Site Plan Review

Site: 27700 Southfield Road
Applicant: Akiva Investments, LLC
Plan Date: October 21, 2024
Zoning: VC Village Center District
Parcel ID: 24-13-303-021
Proposal: Mixed Use: Residential & Commercial

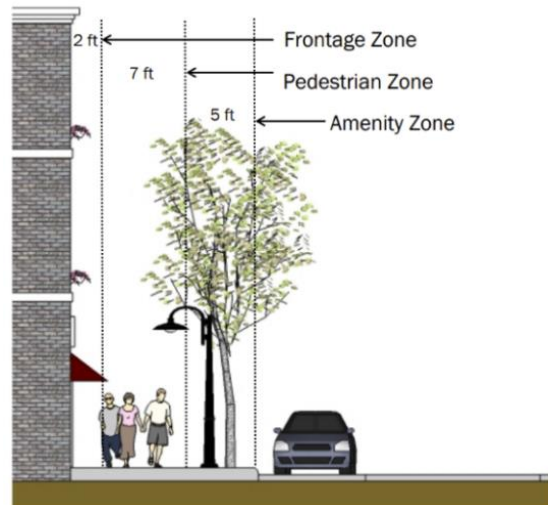
3. Unique to the Village Center zoning district, **all areas between the building and the street curbs shall be paved** in order to create a Frontage Zone, Pedestrian Zone, and Amenity Zone. These zones establish the justification for constructing buildings up to the lot lines. See graphic at right. Sect. 3.1.8.D.1.D.
